1A TELEPHONE ANSWERING SET  
 STATION CONNECTIONS

1.01 This addendum, which supplements Issue 2 of the section and replaces addendum Issue B, provides additional information on connections for the 1A answering set.

Fig. A  
 Connections for 1A Answering Set When Used With PBX Trunks.

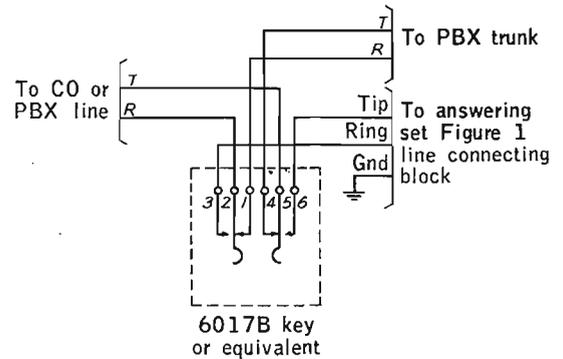
1.04 When the 1A answering set is connected to a PBX trunk circuit, it shall be wired as shown in Figure A.

NOTE: When Figure A is used, the answering set must be equipped with a separate telephone set.
